**WHEELING PLAN COMMISSION
THURSDAY, SEPTEMBER 13, 2018 6:30 P.M.**

**AGENDA FOR A REGULAR MEETING OF THE PLAN COMMISSION
Board Room - 2 Community Boulevard, Wheeling, Illinois**

RE: **Docket No. PC 18-15**
Pizza Roncadin
236 Egidi Drive
Minor Site Plan and Appearance Approval of a Nitrogen Tank

RE: **Docket No. 2018-23**
H2O Express Car Wash
966 S. Milwaukee Avenue
Special Use-Site Plan Approval of a Car Wash Facility

A-3.2

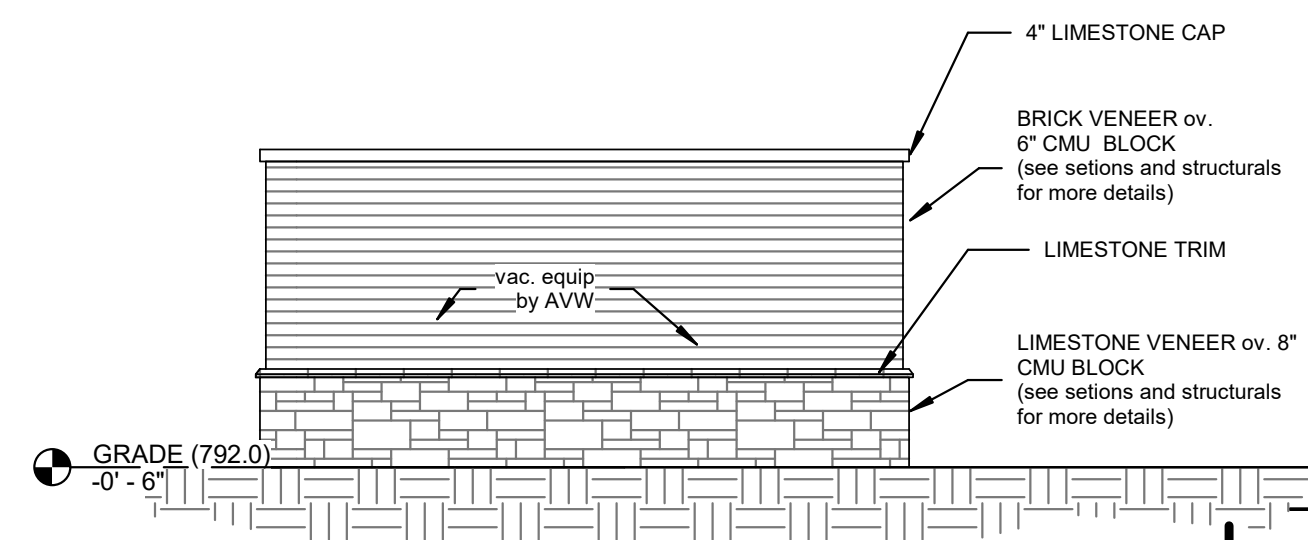
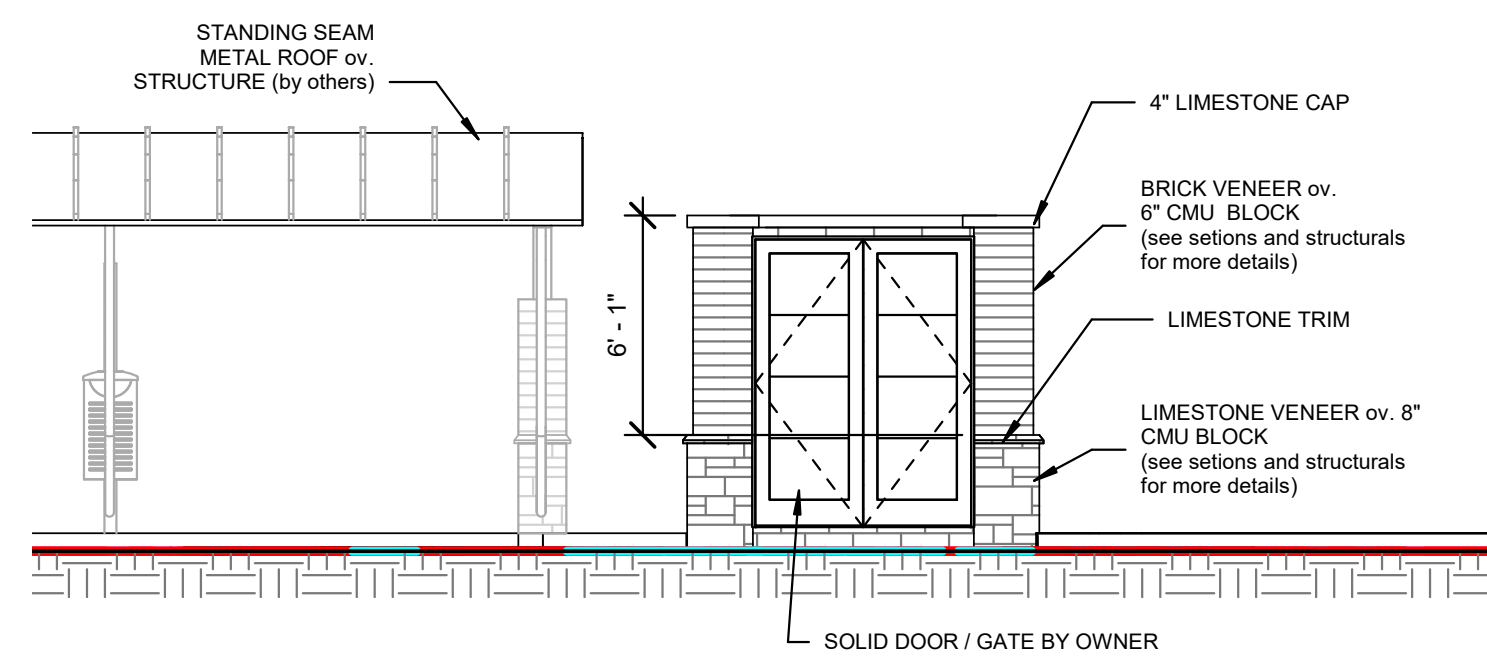
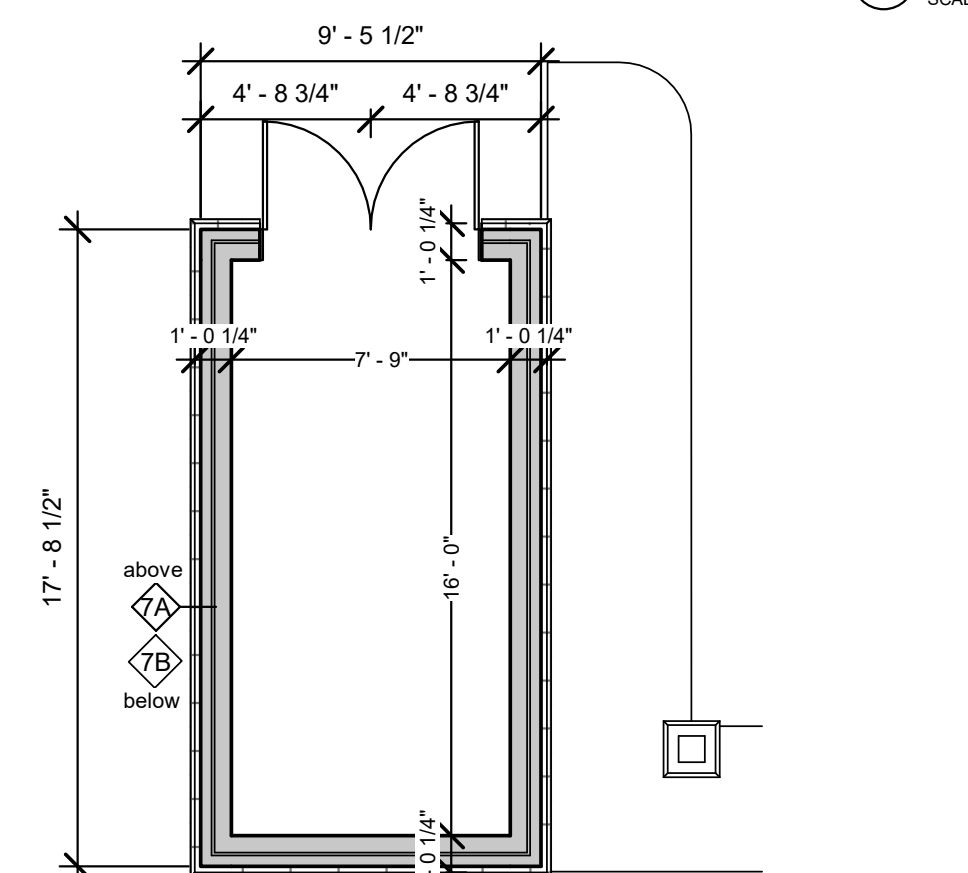
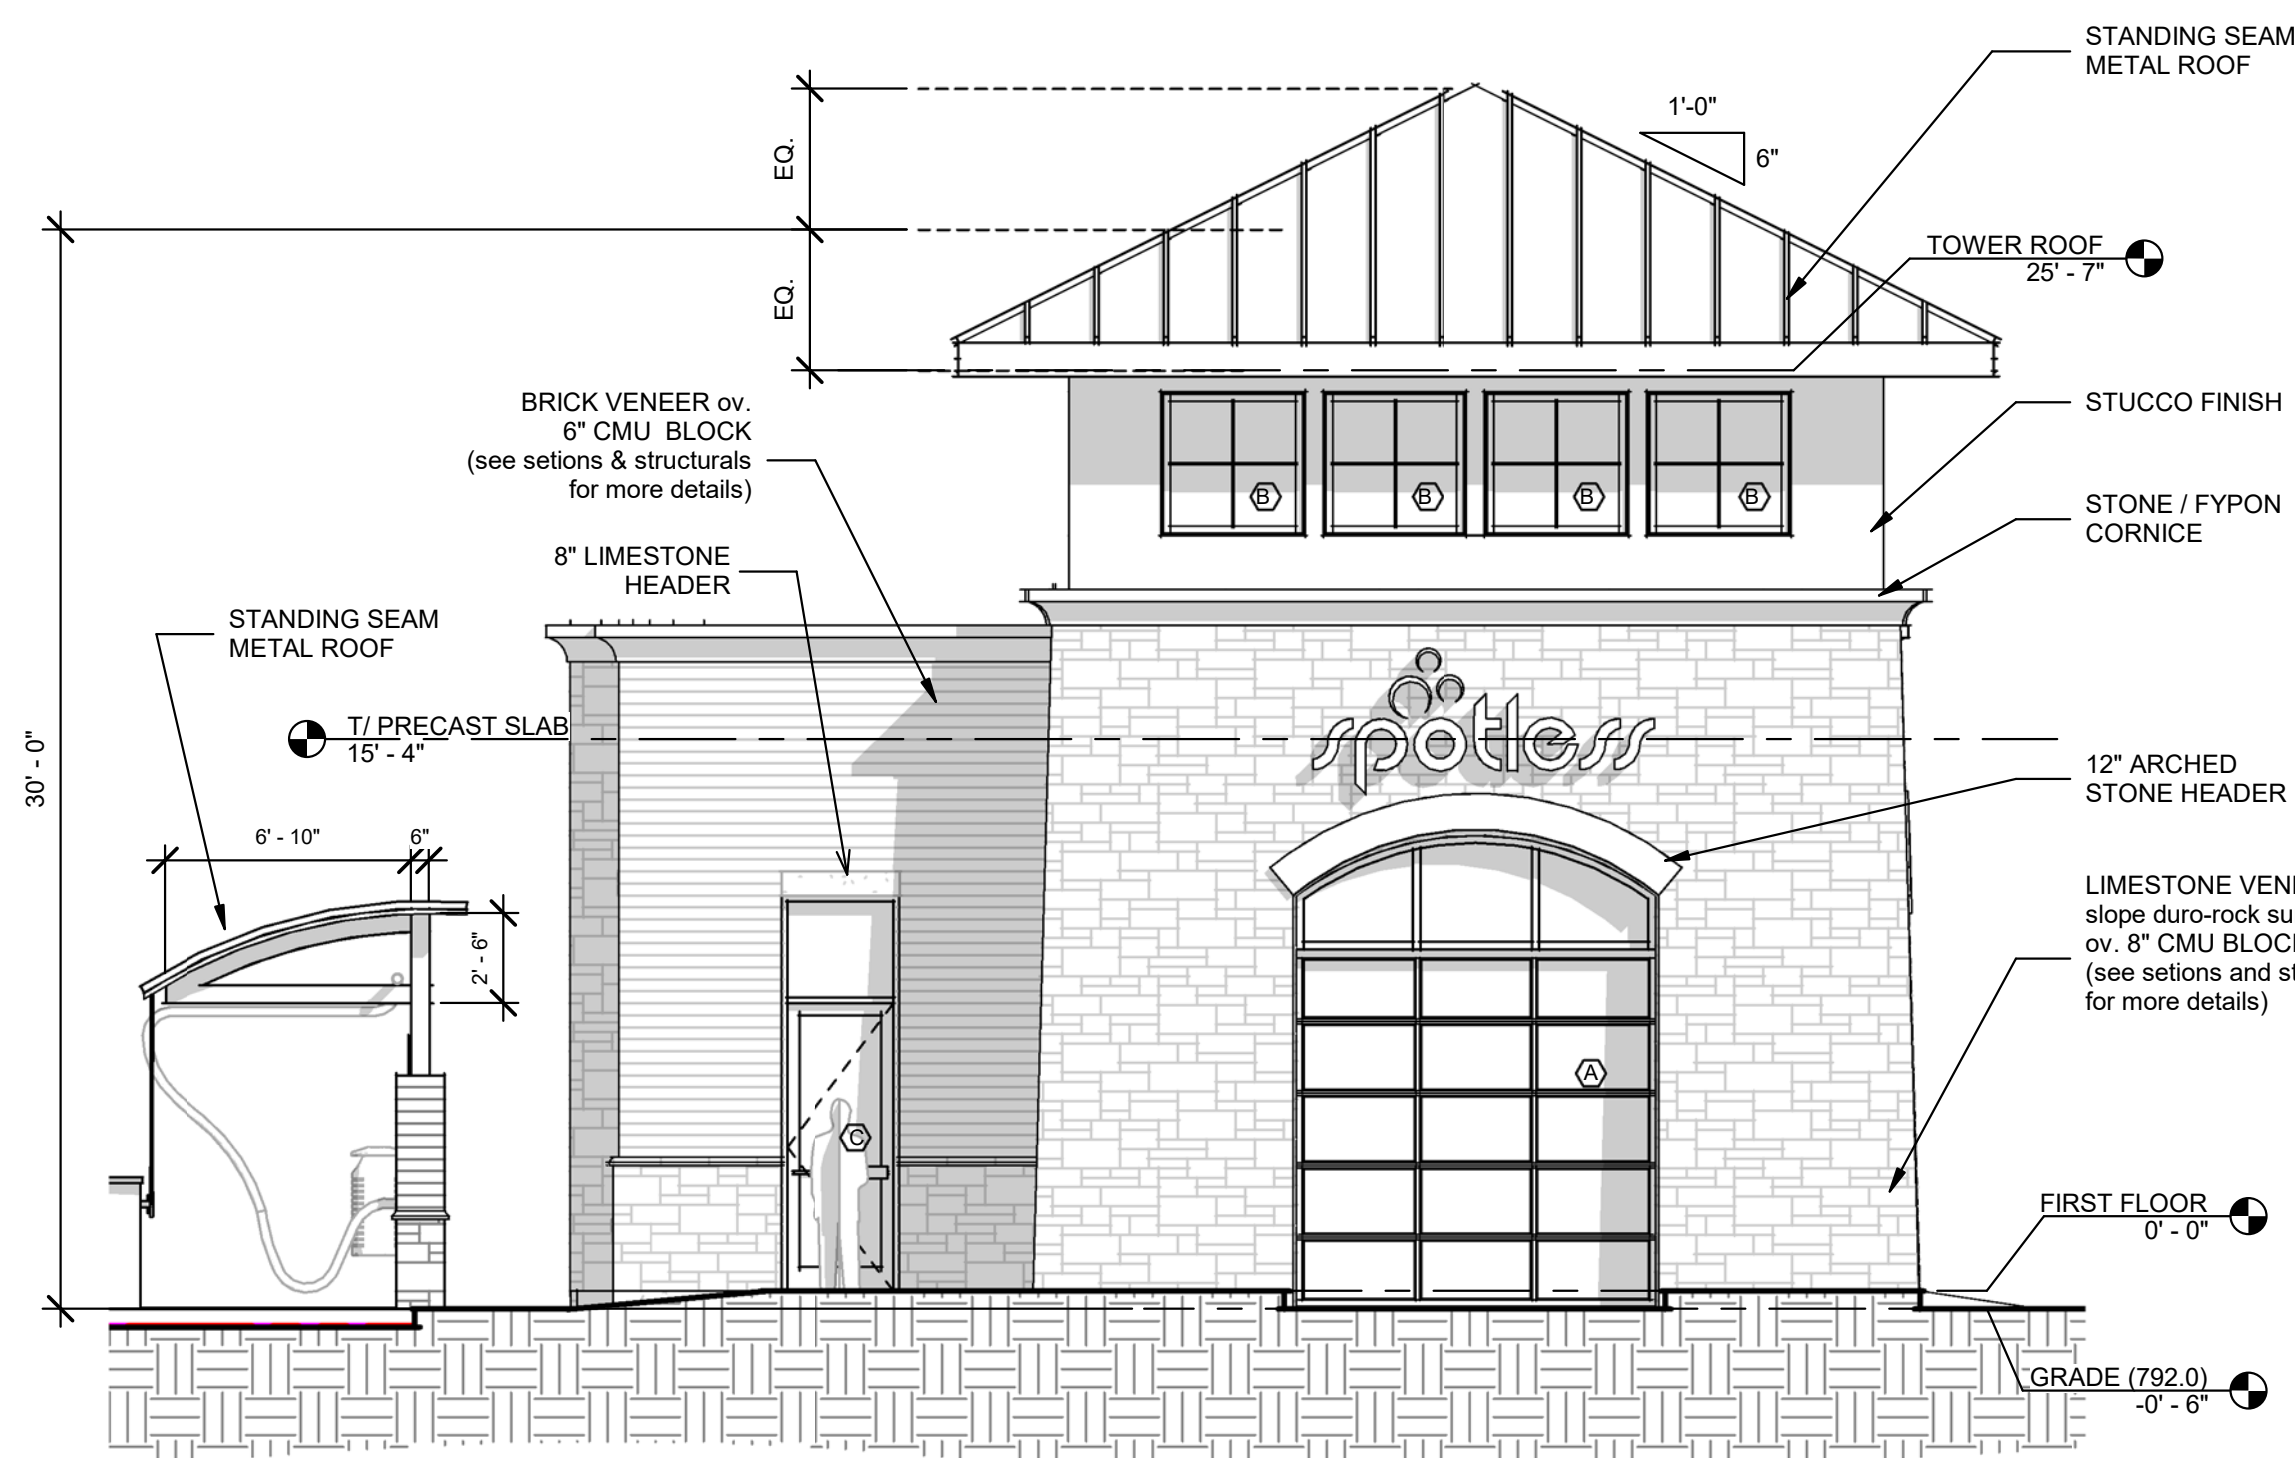
Elevation plans: Renderings and elevation plans are provided to describe the building exterior. It appears that the elevation labels are incorrect. The front elevation should be labeled east. The rear elevation should be labeled west. The main elevation should be labeled north and the side elevation should be labeled south. The front and rear elevations include tower elements with a metal standing seam hipped roof and clerestory windows below the roof line. Each lower wall of the tower elements are clad in limestone veneer. Overhead garage doors with a divided lite design and a 12 inch arched stone header are located on the east and west tower elevations. Fixed glass windows that are similar in design to the overhead garage doors appear on the south elevations of the towers. Between the east and west towers is a long stretch of flat roof with a decorative Fypon (synthetic stone) cornice. The majority of the north and south walls of this wash tunnel portion of the building is covered in brick. There is also four foot high raised foundation of limestone veneer. The same limestone veneer is carried vertical on pilasters that provide relief on each the north and south walls. A limestone trim separates the brick and limestone wall materials. Fixed windows are located throughout the north and south elevations. Limestone headers are shown above the windows. The Plan Commission may wish to inquire about the tint or opacity of the window glazing.

Trash Enclosure: A trash receptacle is situated at the northeast end of the parking aisle. Sheet A-3.2 provides elevation plans of the enclosure. It appears that the labels of these elevation plans are incorrect. The "west elevation" appears to actually be the south elevation, which includes the gates. The "south elevation" appears to actually be the east and west elevations with solid walls of brick veneer above a limestone veneer. The enclosure also has a limestone cap and limestone trim between the brick and limestone veneers. The appearance of the enclosure matches the building.

Signage: Multiple wall signs are shown on the elevation plans. Not enough detail is provided at this time to review or approve the signs. The sign plans shall be illustrative only.
